**From:**  
**To:** [DCAdmin](#)  
**Subject:** 2020/62/93954  
**Date:** 03 December 2022 19:33:37

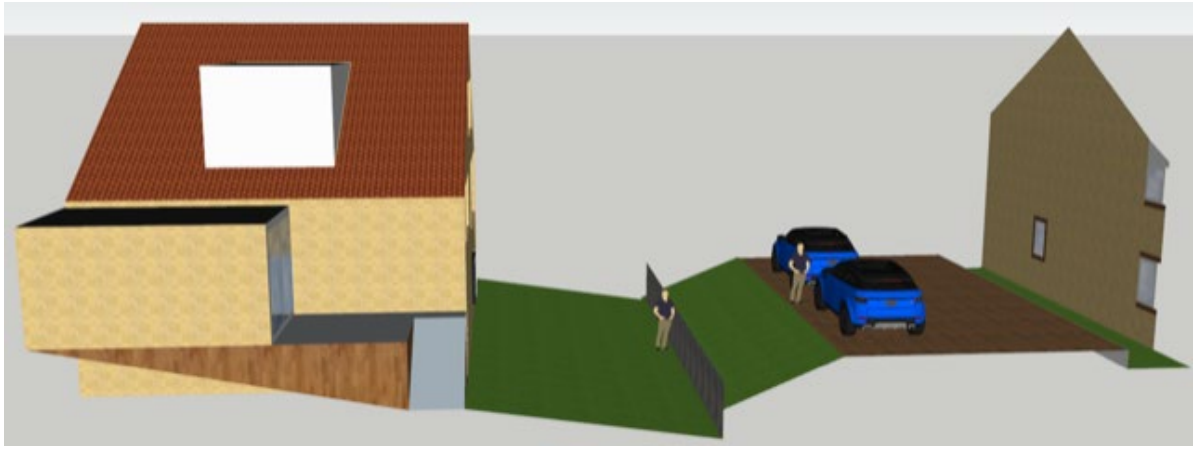
It appears that the windows of the lounge in flats 15/ 16 are not the required distance of 21 metres from my property no 45 Lingards road.

The reduction of 200mm for the road level is laughable.

The plans differ with disingenuous measurements from my fence to the gable end of the flats 15/16 designed to imply that the road distance and level will have no impact on my house and outdoor leisure area.
